## **Statement of Compliance Access for People with a Disability**

### **Proposed Mixed Use Development**

890 Woodville Rd Villawood

**Report Type:** Statement of Compliance - BCA Access Provisions  
**Development:** 890 Woodville Rd Villawood

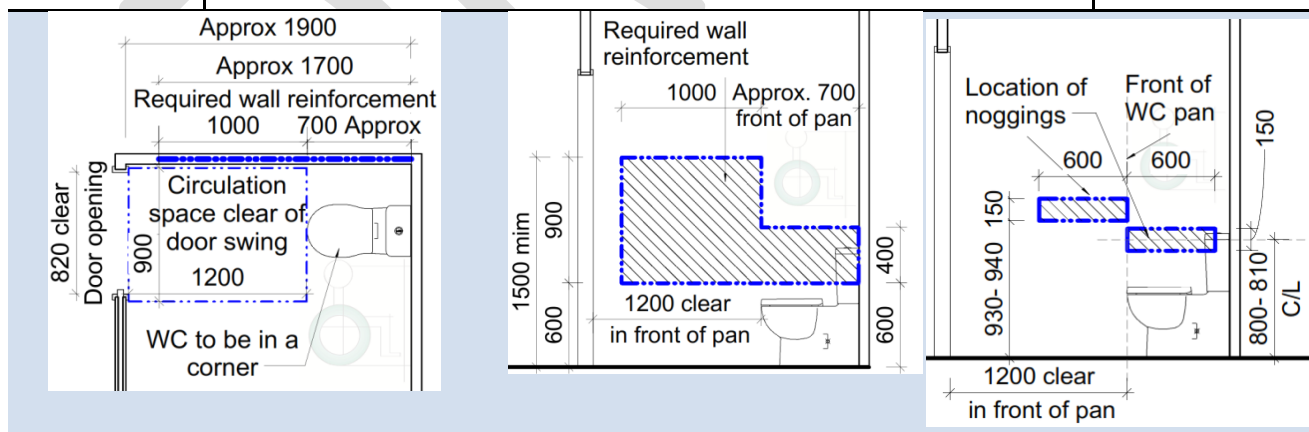
Since **15** of the units (**802A, 901A, 1002A, 107B, 109B, 201B, 212B, 301B, 312B, 401B, 501B, 601B, 701B, 805B & 905B**) already comply with the Adaptable unit requirements, these units are also capable of satisfying the intent of Silver level of Livable Housing Guidelines as noted in the table below.

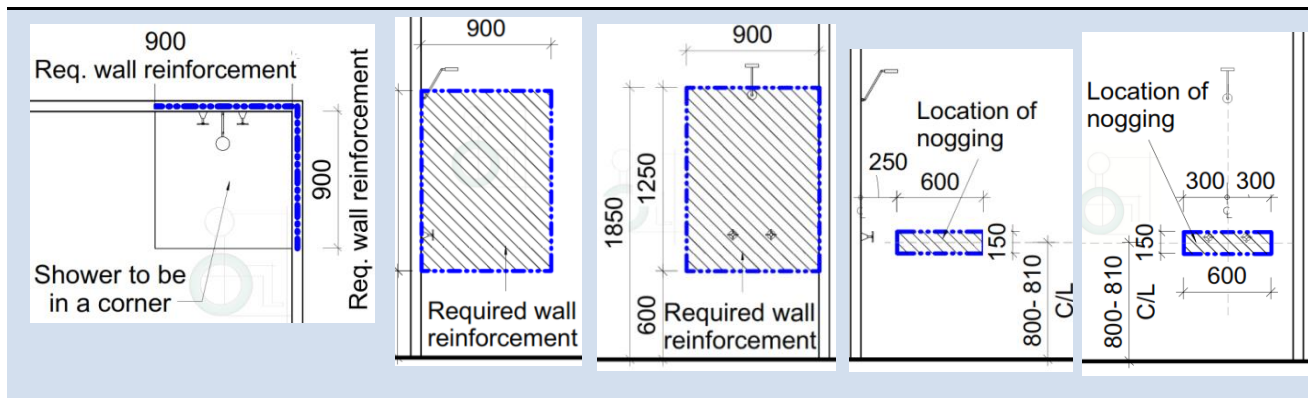
In addition to the adaptable units provided the following 16 units **208A, 308A, 403A, 406A, 503A, 506A, 603A, 606A, 703A, 706A, 205B, 305B, 405B, 505B, 605B & 705B** are capable of providing compliance with the features of Silver level of Livable Housing Guidelines as noted in the table below.

By incorporating the requirements of the below Checklist in the Specifications of the project, the nominated Livable units can achieve full compliance with Livable Housing Guidelines- Silver Level
